PERMIT CHANGE TRACKING FORM

Title: <i>Refuse Pile Diversions</i>	PERMIT NUMBER: <i>007/085</i>
Description: <i>Abatement of NOV N94-26-4-1</i>	PERMIT CHANGE #: <i>945</i>
	MINE: <i>Sunnyside Logan</i>
	PERMITTEE: <i>Sunnyside Logan Assoc. etc.</i>

Title of Change: **SUNNYSIDE COGENERATION ASSOCIATES**
Redesign of RC-D6 to install 36" Culverts RC-C1, RC-C2, & RC-C3
Associated with NOV N94-26-4-1

RE: Draft Review, 100 Year 6 Hour Diversion down Refuse Pile, Sunnyside Cogeneration, Sunnyside Cogeneration Associates ACT/007/035-94J, Working file, Carbon County, Utah

TYPICAL DRAWING FOR INSTALLING OF 36" CULVERTS
RC-C1, RC-C2, RC-C3 AND ENERGY DISSIPATOR/SPLASH POOLS

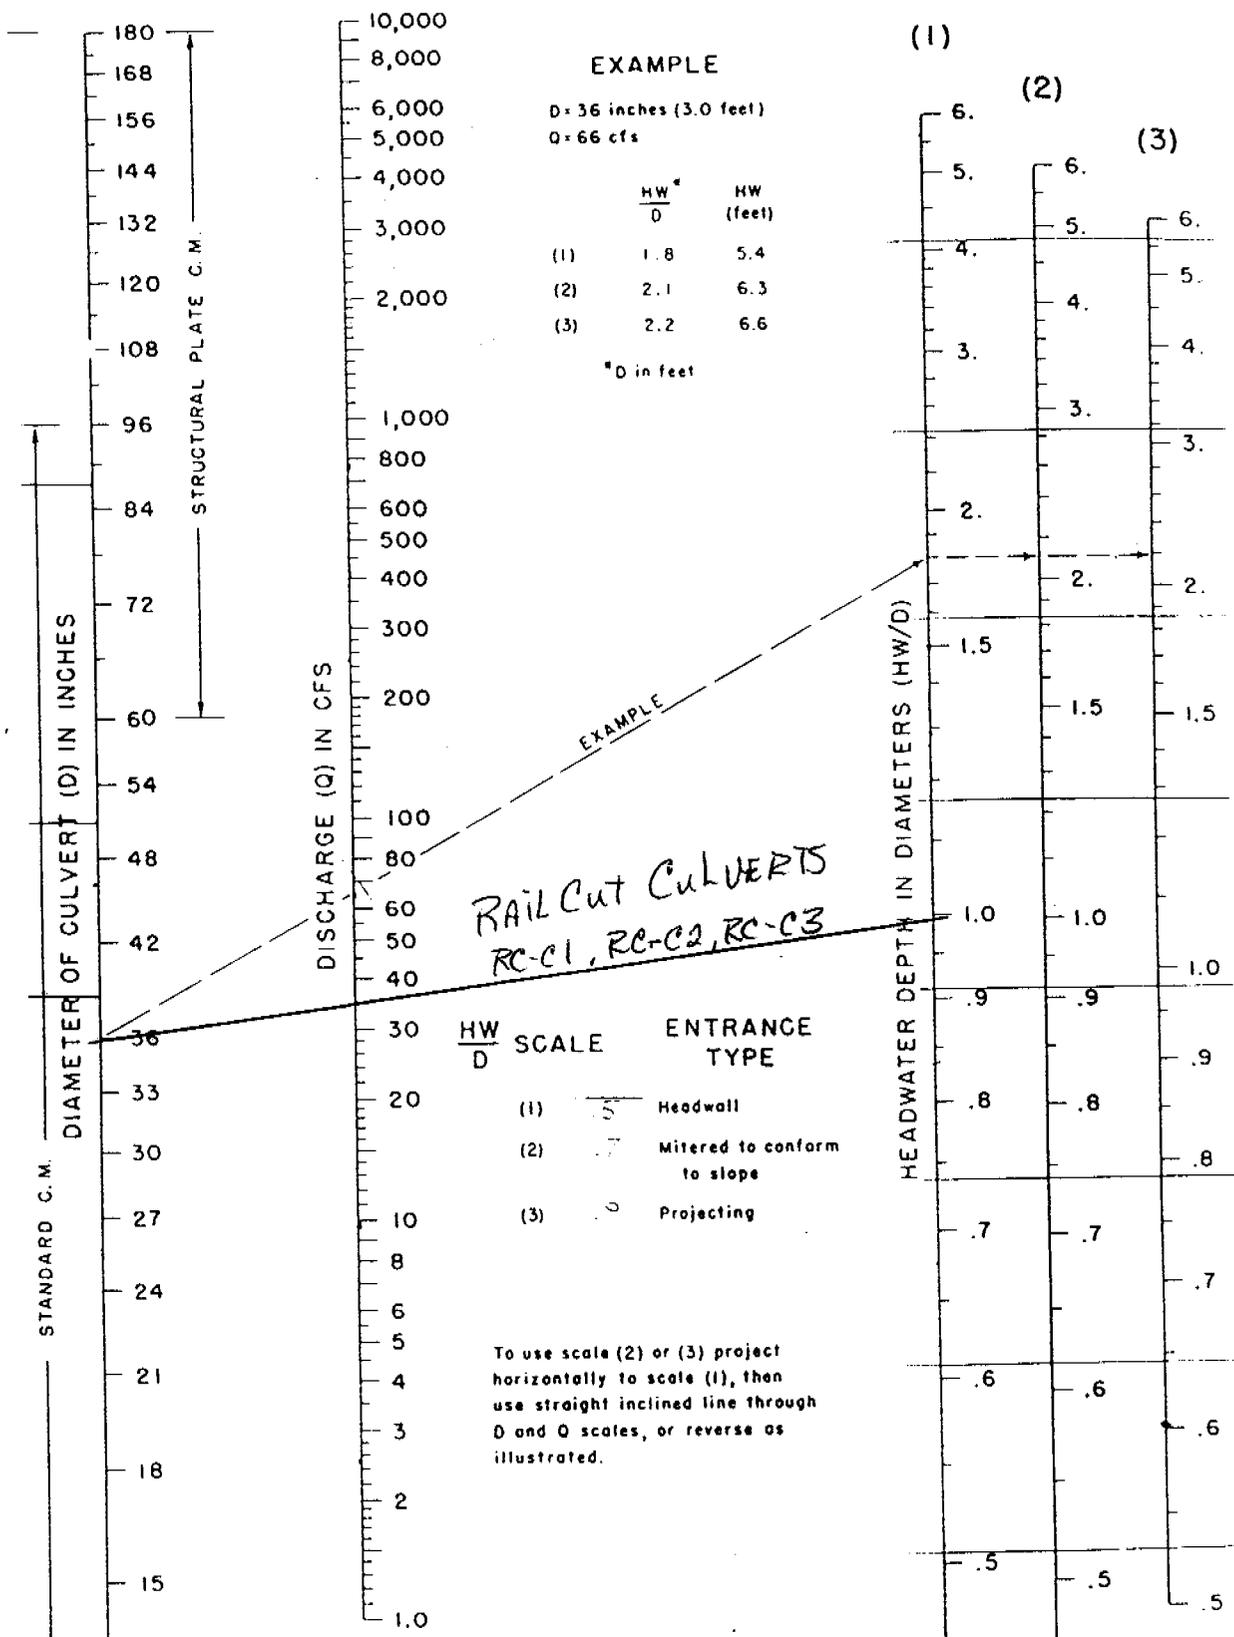
The permittee proposes replacing ditch D-6 with culverts C1, C2, C3. The 100 year 6 hour storm peak is 13.3 cfs for ditch D-11, the end point of the system or the ditch prior to the Railcut pond, as referenced in Appendix 7-3 of the permit. The culverts are designed to pass 35 cfs as shown on the attachment submitted with the amendment. Although not shown on the submittal but documented in a phone call with Mr. Scott Carlson of Eckhoff, Watson and Preator on November 9, 1994. The inlet to Culvert C-1 will have a standard culvert end section and berm will funnel all receiving waters into that culvert.

Based on the excess peak flow capacity of 21.7 cfs from the previously approved storm peaks, the 36 inch culverts are approved to be installed.

1. The permittee must submit any revisions based on as-built designs and must have an engineer stamp all drawings prior to final submittal. As-built drawings must reflect inlet control on Culvert C-1.
2. All information submitted must be incorporated into the mine plan and the appropriate tables modified in Appendix 7-3 to reflect the elimination of Ditch D-6. This can be accomplished at the same time as submittal of as-built drawings.

HEADWATER DEPTH FOR PIPE CULVERTS WITH INLET CONTROL

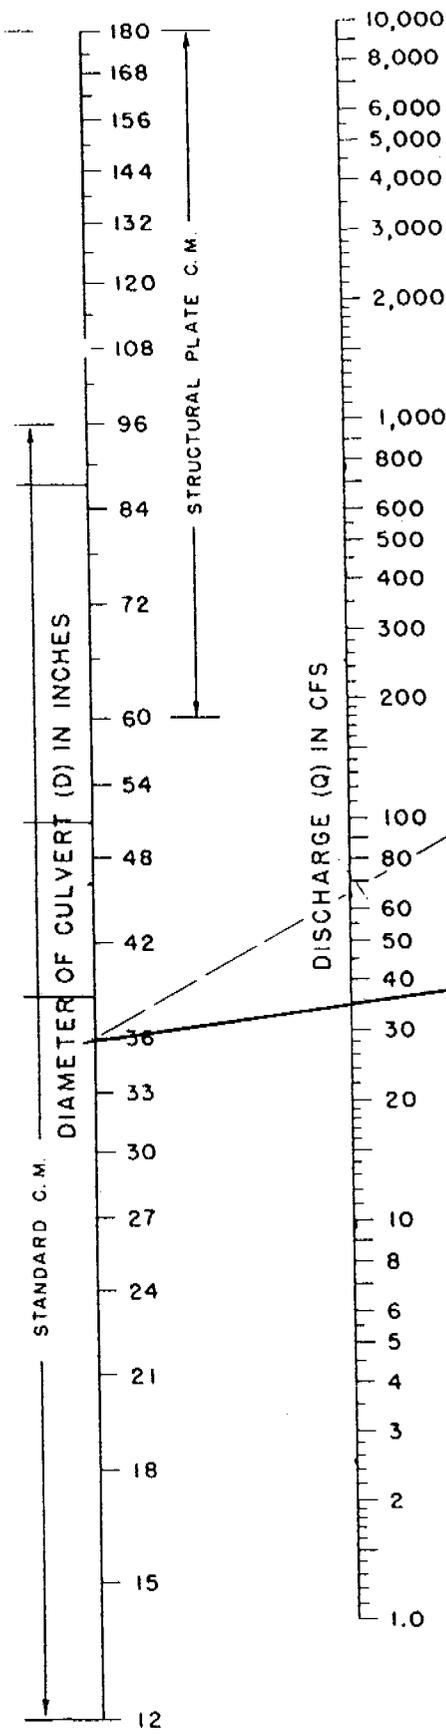
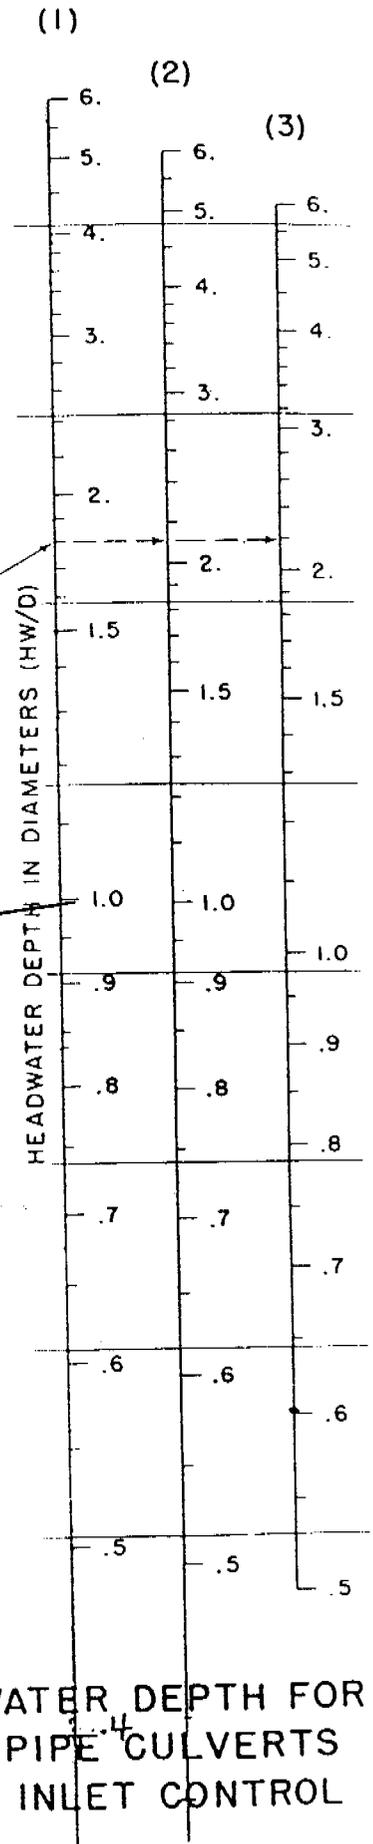
- 1) Certified "as-built" designs of the refuse diversion construction must be submitted within 30 days of the installation of the diversion. The designs must reflect inlet control on Culvert C-1.
- 2) Appropriate numbers of copies of the amendment must be submitted for incorporation into the mine plan which include appropriate tables modified in Appendix 7-3 to reflect the elimination of Ditch D-6. This can be accomplished at the same time as submittal of the as-built drawings.
